Revision

AC Motors

DRN63 – 315, DR2S56 – 80, DR2L71 – 80

This revision describes amendments made to the "AC Motors DRN63 – 315, DR2S56 – 80, DR2L71 – 80" catalog (edition 11/2019). The following chapters in the catalog are amended/revised:

2.1 Revision to the dimension sheet for DRN225..

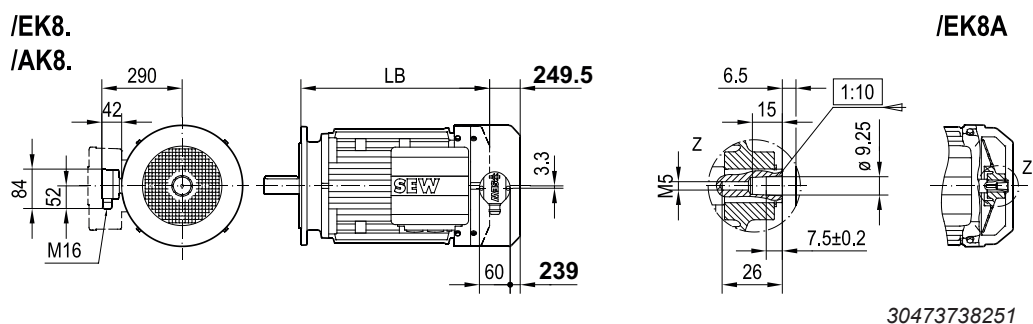
When mounting the latest AK8Y encoder the dimensions of the fan guard and thus the overall length of the motor change.

In the following figures, the dimensions highlighted in bold writing are the revised dimensions.
